AGENDA REPORT

SAN CLEMENTE CITY COUNCIL MEETING
Meeting Date: November 5, 2013

Subject: **CONDITIONAL USE PERMIT 12-362, CULTURAL HERITAGE PERMIT 12-363, DISCRETIONARY SIGN PERMIT 13-082, MINOR EXCEPTION PERMIT 13-084, OUTDOOR DINING PERMIT 13-085, NORTH BEACH ROOFTOP GRILL AND BAR.**

Figure 1- Previous Signage Proposed

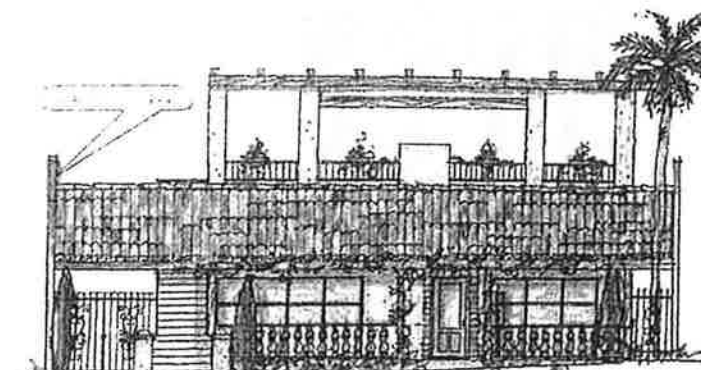
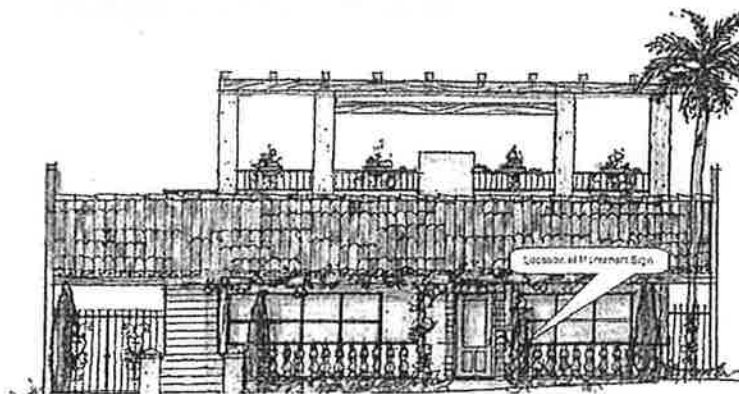
In response to the concerns brought up at the previous DRSC meeting, the applicant has developed new signage for the site, as shown in Figure 2. The applicant is proposing the same type of signs but has changed the design from a route 66 look to a more contemporary design. Here are the sign designs (the locations for each sign is the same as shown above):

Figure 1: Proposed Signage

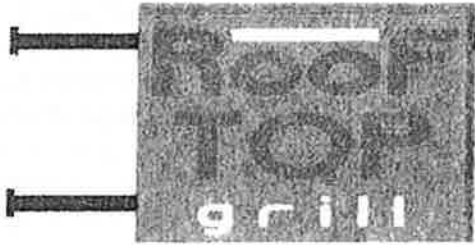
The proposed materials appear more industrial than those that have typically been submitted in the Architectural Overlay. However, the signs will be handmade and will be unique for the site and in that way consistent with the Architectural Overlay standards.
